SERVICE BULLETIN

Herewith Revision No. 2 of Service Bulletin A320-21-1014.

SERVICE BULLETIN No.: A320-21-1014

T I T L E : AIR CONDITIONING - AIR COOLING - MODIFY FLOW CONTROL VALVES AND RELOCATE PRESSURE SENSORS

Installation of Air Conditioning Components Figure 10, Sheet 1 of 5

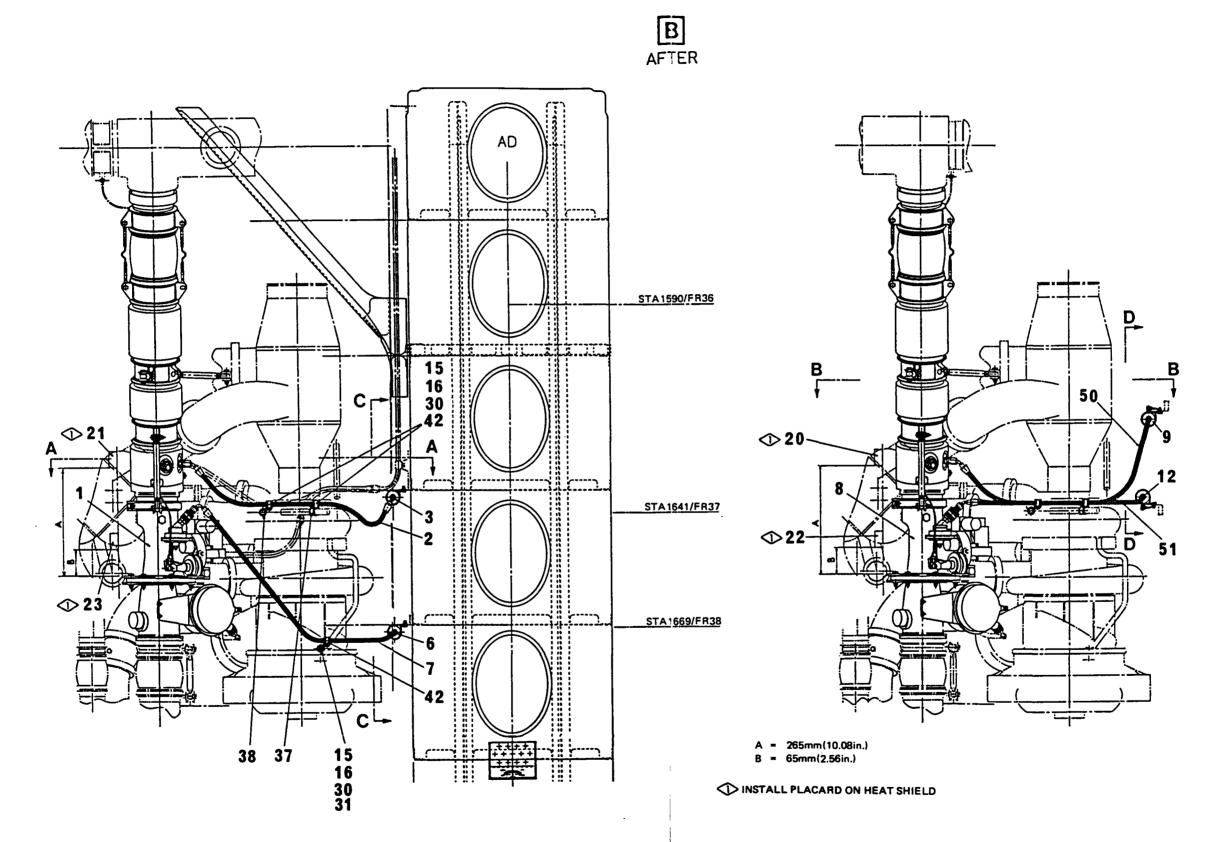
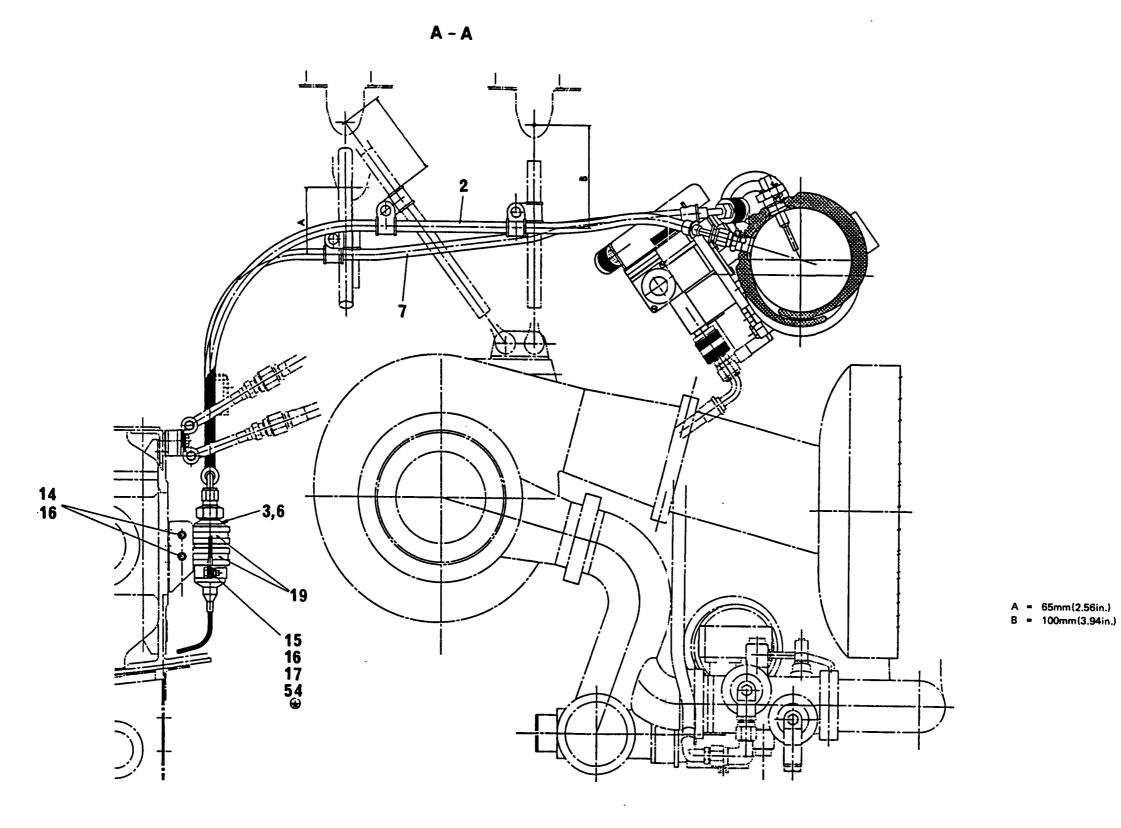
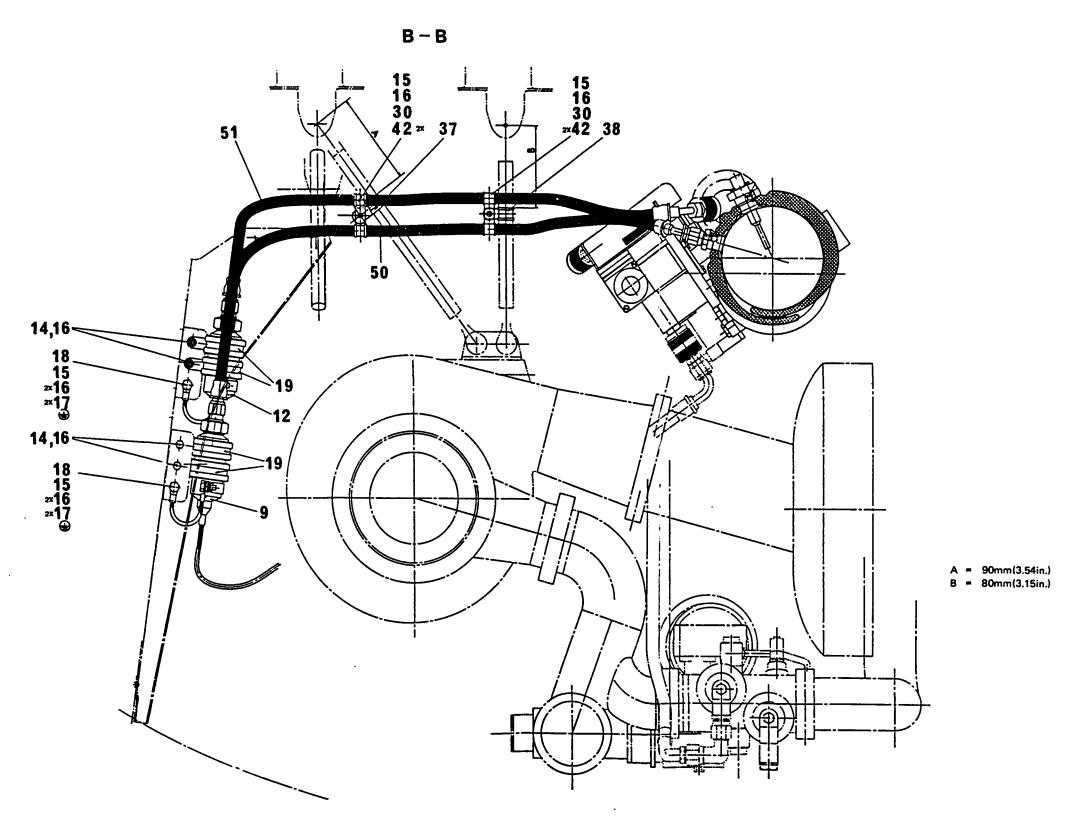
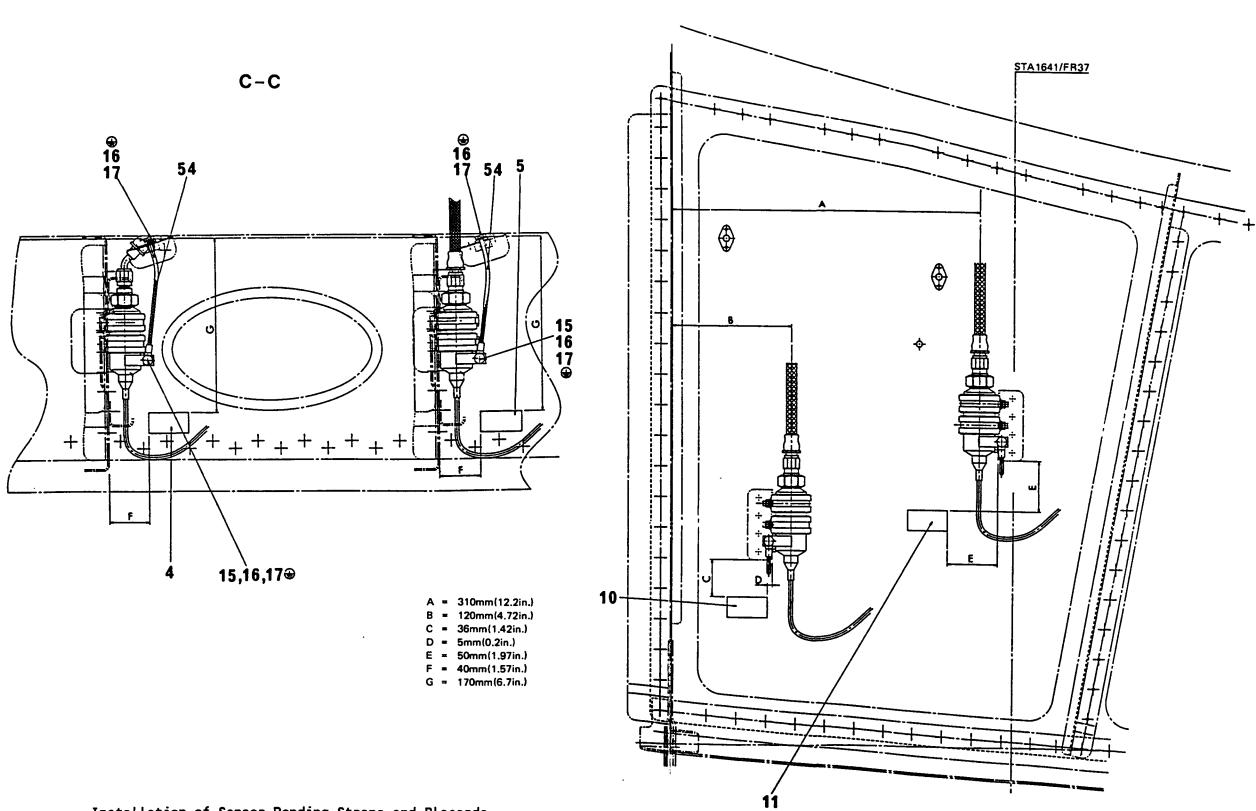
(a) Install the retained sensors 763A0000-03, item 3 and 6 on the keel beam sidewall, LH with:

- (b) Install the new bonding straps E0089-10-200, item 54 with screws NAS6703U1, item 17, washers AN960C10L, item 16 and nuts MS21043-3, item 15.
- (c) Install the retained sensors 763A0000-03, item 9 and 12 on the longeron assy, RH with:

- (d) Install the retained bonding straps E0090-10-100, item 18 with screws NAS6703U1, item 17, washers AN960C10L, item 16 and nuts MS21043-3, item 15.
- (e) Install the placards adjacent to the sensors according to figure 10, Sheet 5:

(1) Connect the hoses, item 2 and 7, LH and item 50 and 51, RH to the appropriate sensor as shown in figure 10 and secure with:

clamp	MS21919WCJ6	item 42
clamp	MS21919WCJ8	item 38
clamp	NSA5516-15NJ	item 37
clamp	NSA5516-13NJ	item 31
screw	A104-1/2D	item 30
washer	AN960c10L	item 16
nut	MS21043-3	item 15

Electrical Modification Figure 11, Sheet 1 of 5

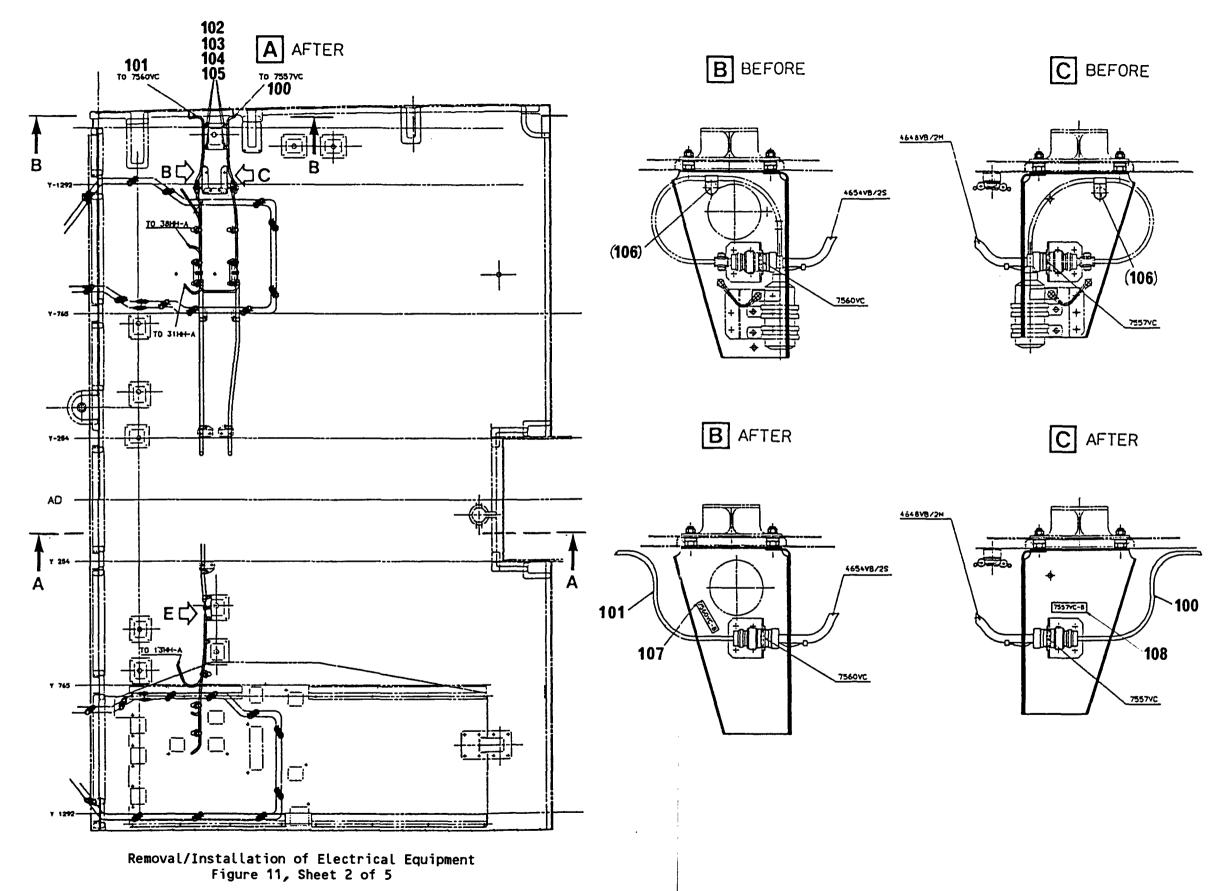
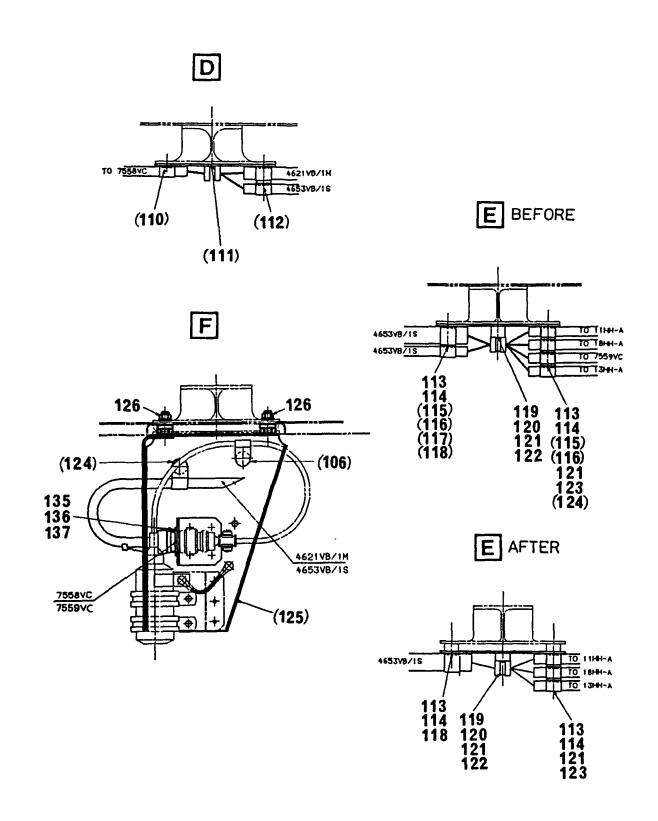
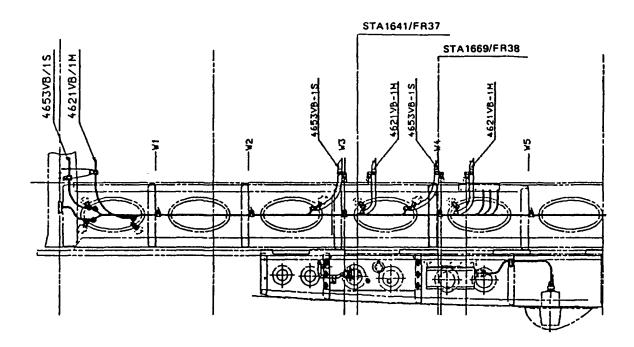
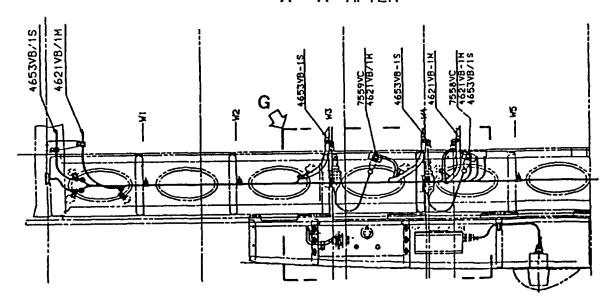
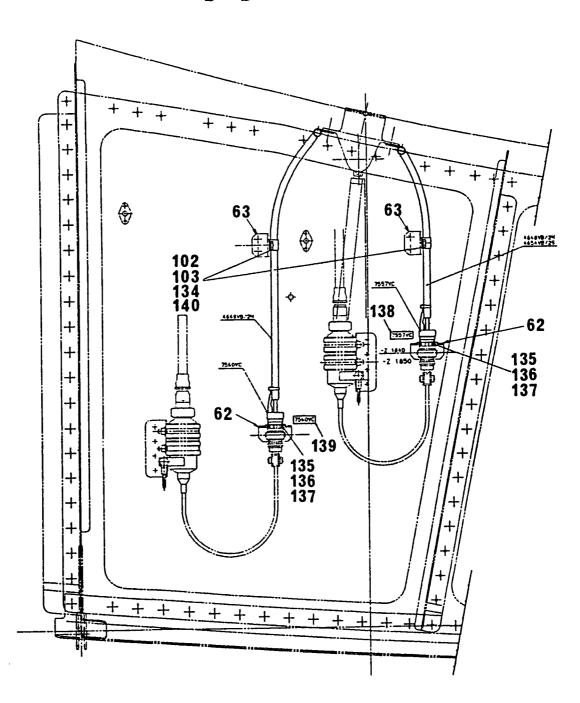
- (a1) Remove and do not re-use clamps, item (106), (110), (111), (112) and (124) with fastening parts.
 Refer to details B, C, D and F.
- (a2) Modify the cable fastening in accordance with detail E and remove and install as follows:

- (a3) Remove the receptacles 7558VC and 7559VC from the brackets. Retain the screws, item 135, washers, item 136 and nuts, item 137.
- (a4) Remove and discard the support, item (125). Re-use the fastening parts, item 126 to seal the existing holes.
- (a5) Re-route the cable bundles 4621VB/4653VB and install the receptacles 7558VC and 7559VC to the brackets, item 91 as shown in detail G with the retained:

- (a6) Install the placards, item 150 for receptacles 7558VC and 7559VC which are delivered with the electrical equipment D9299221000000.
- (a7) Secure the cable bundles to the structure (Ref. detail G) with:

- (b) Installation of new wiring.
 - Ref. Figure 11 and 12
 - (b1) Install the cable bundle, item 100 identified on the Hook-up Chart, line 1 thru 7, delivered with the electrical equipment D9299221000000.
 - (b2) Install the cable bundle, item 101 identified on the Hook-up Chart, lines 9 thru 15, delivered with the electrical equipment D9299221000200.
 - (b3) Connect the plugs 7560VC-B to receptacle 7560VC and 7557VC-B to receptacle 7557VC. Install placards, item 107 and 108 delivered with electrical equipment D9299221000000 and D9299221000200. (Ref. details B and C).
 - (b4) Install the receptacles 7557VC and 7560VC of the cable bundles, items 100 and 101 to the brackets, item 62 in accordance with section B-B with:
